Title: Advisory Committee on Reactor Safeguards
 Reliability and Probabilistic Risk Assessment

Date: Friday, April 24, 2015

RELIABILITY AND PROBABILISTIC RISK ASSESSMENT (PRA)

The Subcommittee will hear the latest developments of the HRA methodology and its applications in response to the Commission's Staff Requirements Memorandum M061020. We will hear presentations from the NRC Staff and representatives of the Electric Power Research Institute. And I believe that we also will have an EPRI contractor available on the bridgeline.

Two examples of a and k

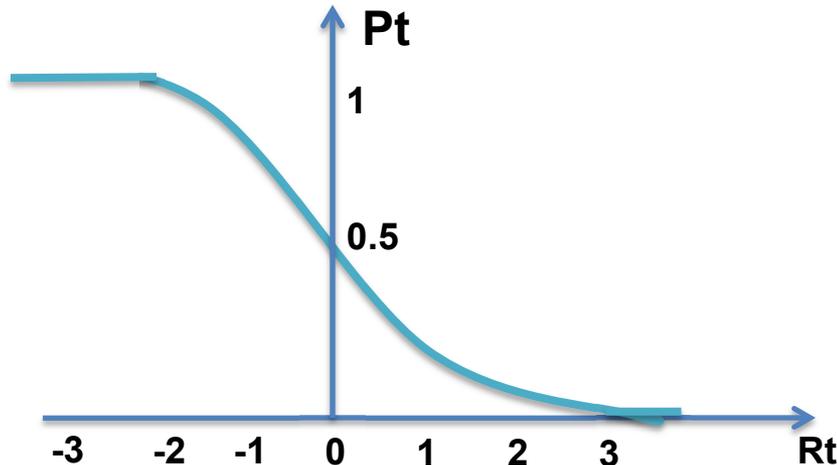
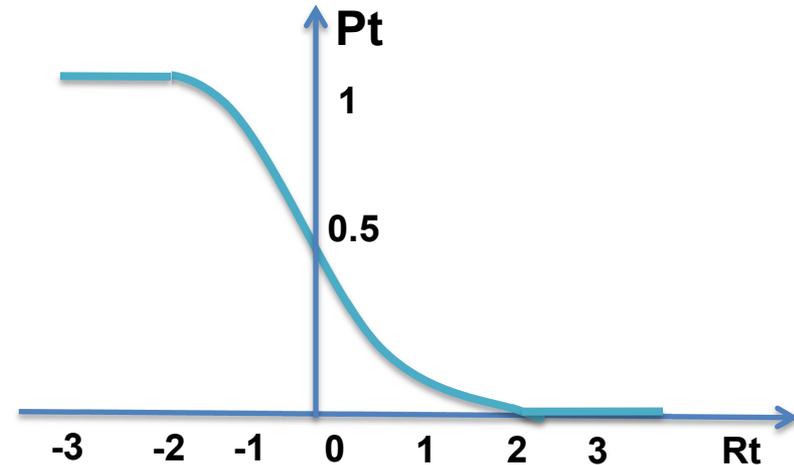
19 CHAIRMAN STETKAR: Not only is it absurd, but
20 the words are not correct, because the two distributions
21 are exactly the same breadth. And you say one is broader
22 than the other, and they're arbitrary. And that is the
23 quote that Dennis found that says "human reliability
24 analysts don't have the access to resources to estimate
25 times." If they don't, fire them. Find somebody who does.

1 CHAIRMAN STETKAR: Okay. Well, think of that,
2 abandon this, because this is just an arbitrary
3 mathematical framework with some assumptions that I
4 couldn't even figure out. And I don't know where you found
5 it, but it doesn't make any sense at all. And it's not
6 physical. If you have those two distributions, you can
7 ---
